PROPOSED BAKERY

1168 W14TH STREET  
NORTH VANCOUVER, B.C.

ACCEPTED AS A REVISION FOR \_\_\_\_\_ Showing the area  
above the office ceiling is not  
\_\_\_\_\_ allowed to be occupied or  
\_\_\_\_\_ used for storage. \_\_\_\_\_

REFLECTED CEILING PLAN

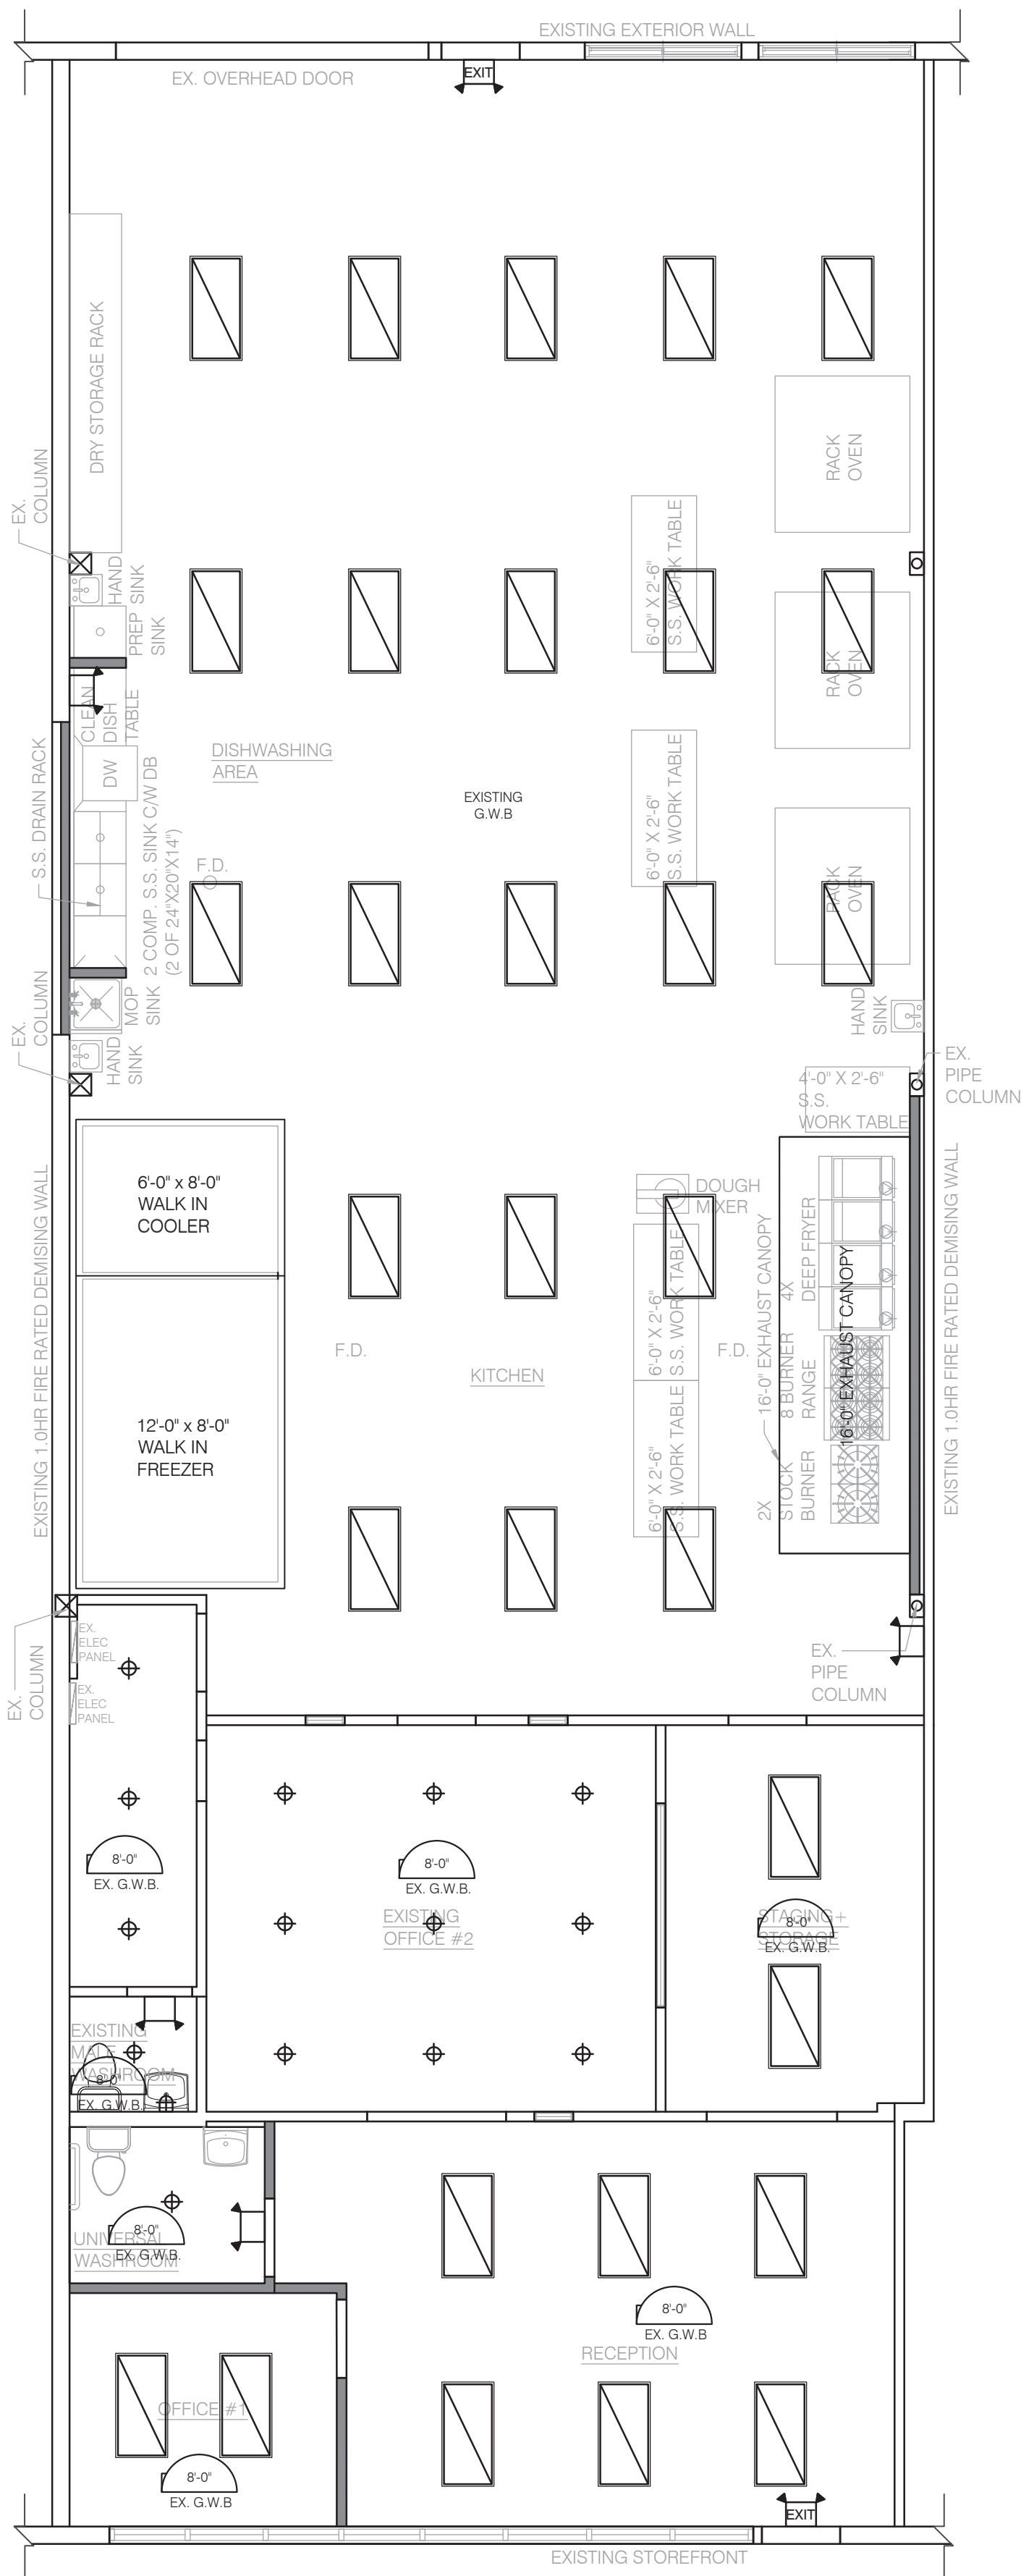
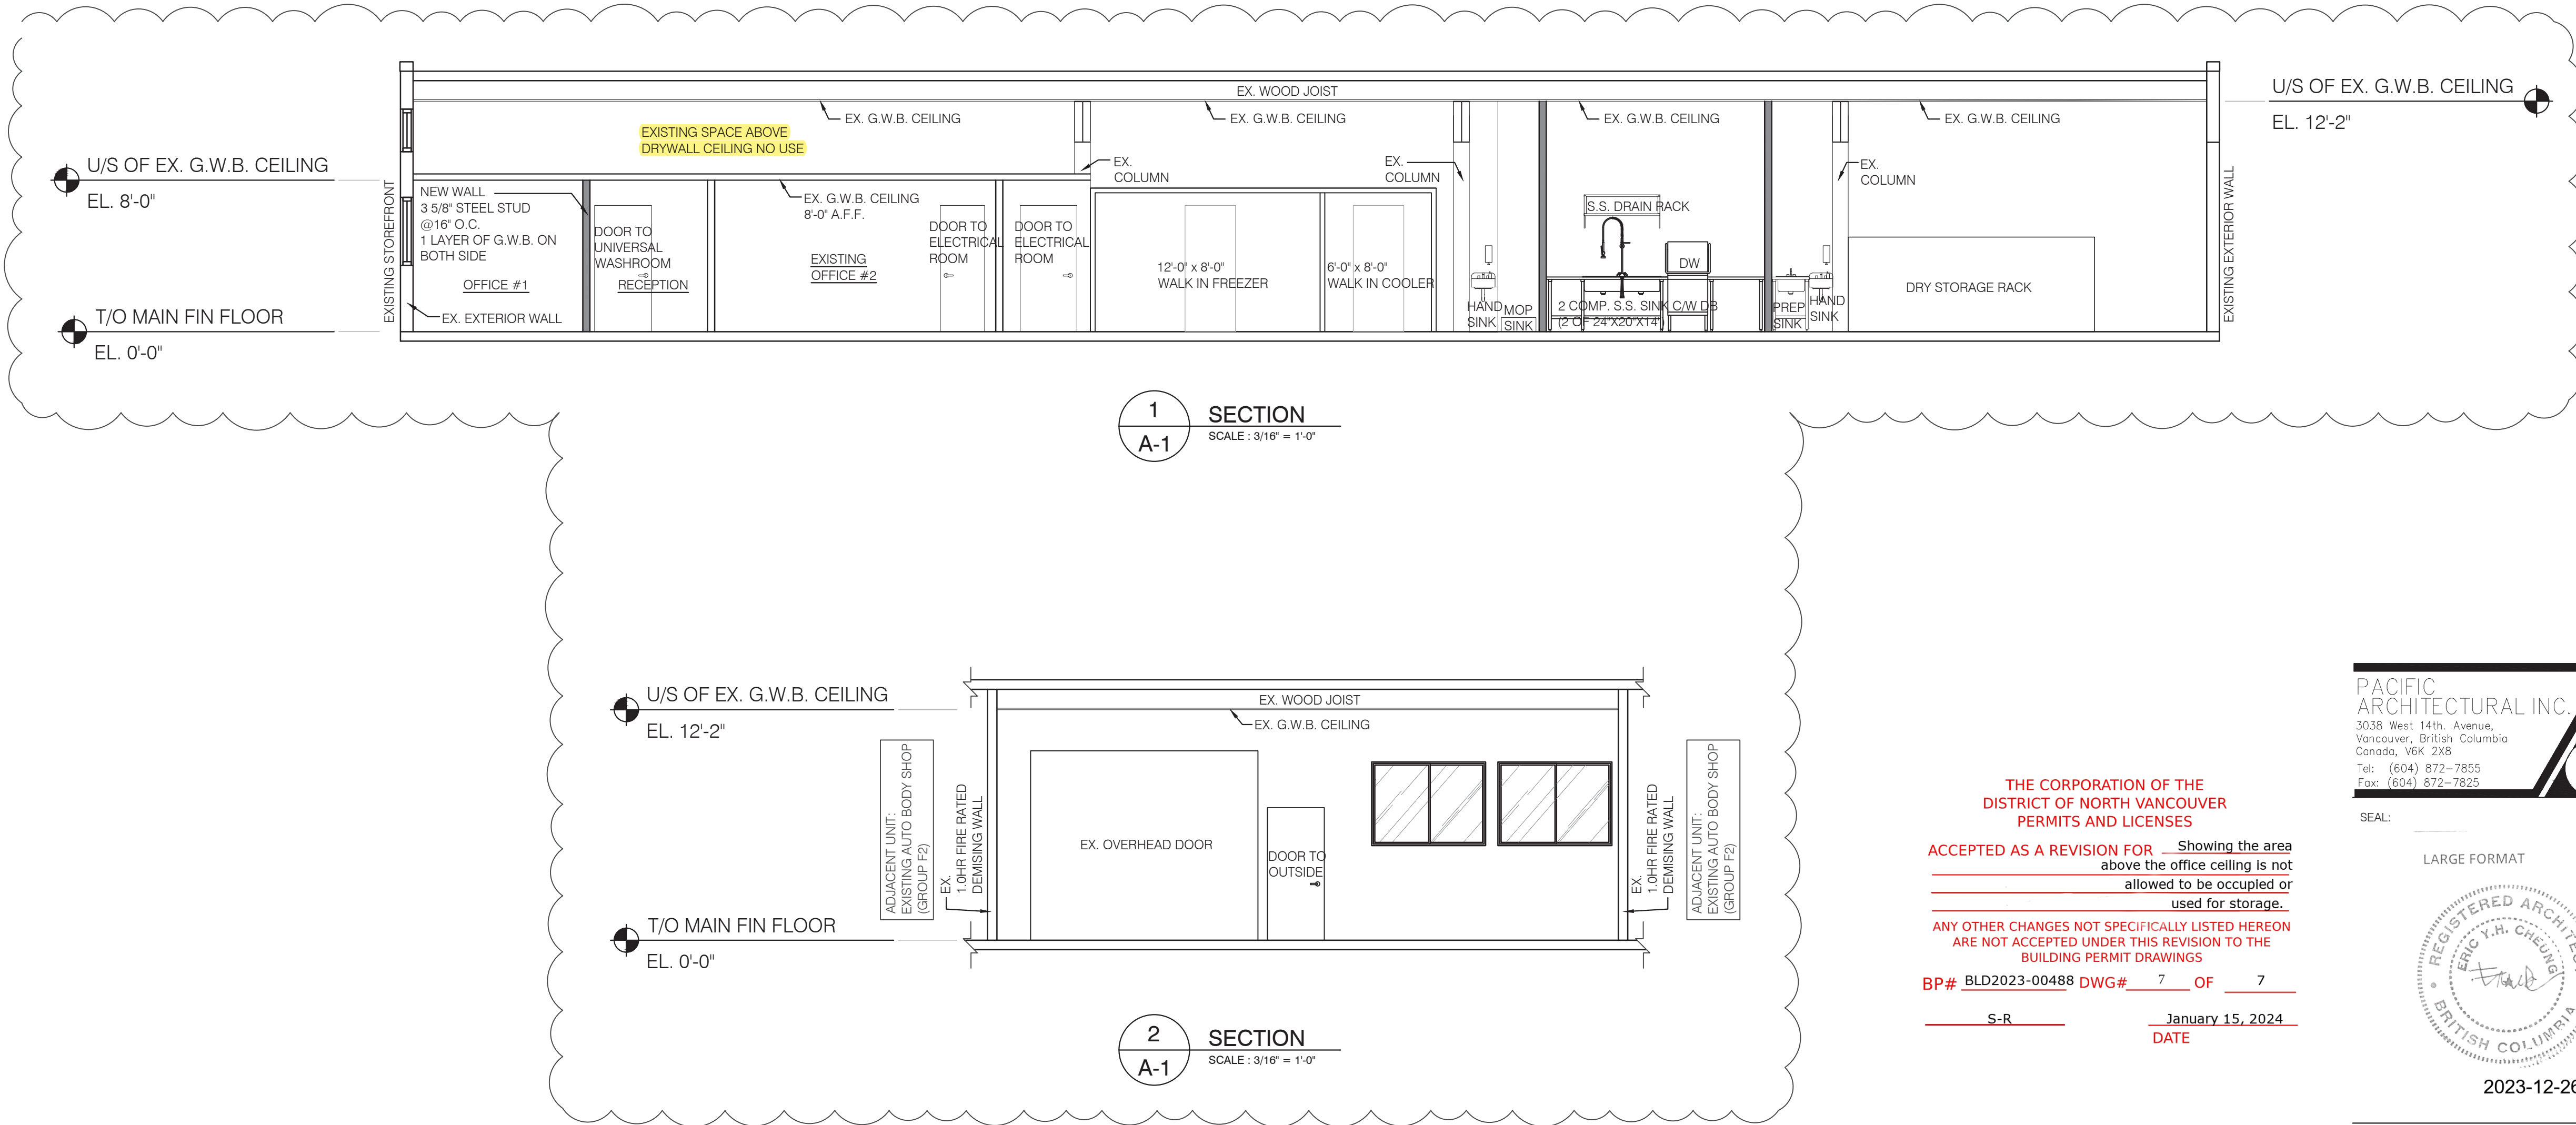
ACCEPTED AS A REVISION FOR Showing the area above the office ceiling is not allowed to be occupied or used for storage.
